RE: Response to Department of Planning, Industry and Environment comments

Eco Logical Australia Pty Ltd (ELA) has been asked by Architectus on behalf of the Department of Education to provide an explanation regarding the comments provided by the Environment, Energy and Science Group (EES) in the Department of Planning, Industry and Environment (DPIE) following their review of the Biodiversity Development Assessment Report (BDAR) version 4 prepared by ELA (last updated on 10 March 2020) for the Chatswood Education Precinct State Significant Development (SSD) application (SSD 9483).

Figure 1: Snippet of Six Maps topographic map baselayer showing development site in blue square

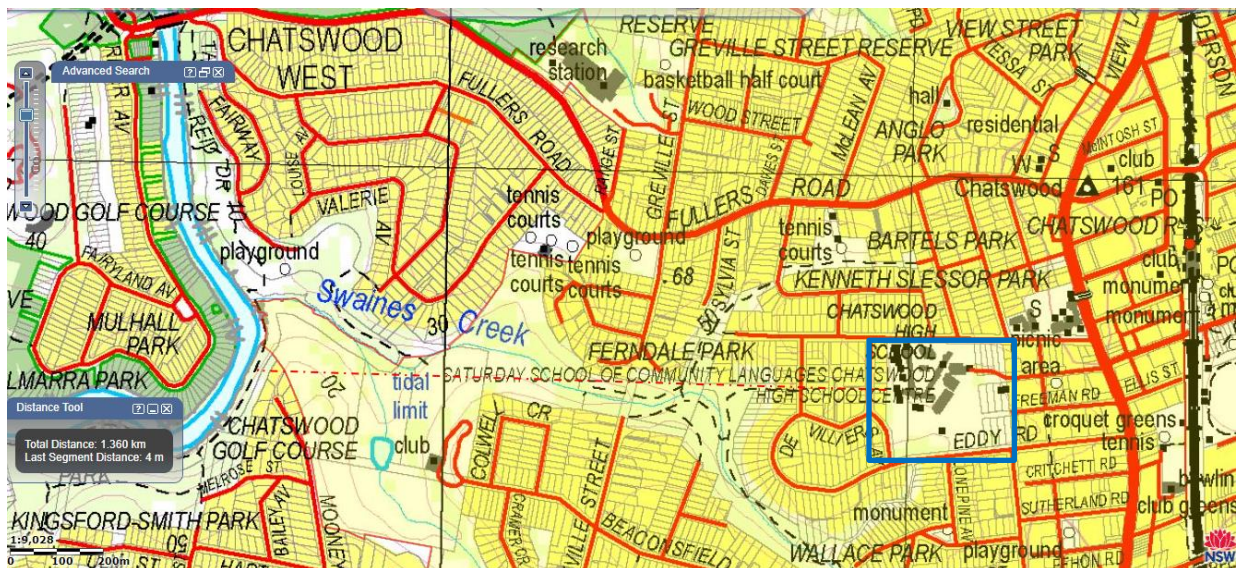
Section 1.3.2 states that “The development site falls within the Pennant Hills Ridges and Port Jackson Basin Mitchell Landscapes The Pennant Hills Ridge Mitchell Landscape has been mapped over site 2 and a portion of site 1 (Figure 2). The majority of site 1 is represented by Port Jackson Basin Mitchell Landscapes. The Port Jackson landscape has been used in the BAM Calculator for both cases.” However, EES considers that the Pennant Hills Ridges is the more appropriate NSW Landscape that should be selected, considering:

ELA included Port Jackson Basin Mitchell Landscape as the most appropriate based on the larger extent of the site covered by this landscape as per the BAM operation manual Stage 1. Which states: “if the subject land is located within more than one BioNet NSW Landscape, the assessor should select the BioNet NSW landscape in which the largest proportion of impact will occur.”

ELA also understands that the Operational Manual also states that if an adjacent landscape more accurately reflects the landscape based on field observation then it should be chosen, and justifications provided in the BDAR.

The landscape is currently in a highly urbanised environment in Chatswood. A small patch of remnant vegetation is located in the southern and western portion of development site however, this portion of the site was not included in the area to be impacted. The remaining areas were subject to substantial alternation of the soil profile and planted native vegetation.

ELA has updated the assessment based on Pennant Hills Ridge Mitchell Landscape in both of the development cases.
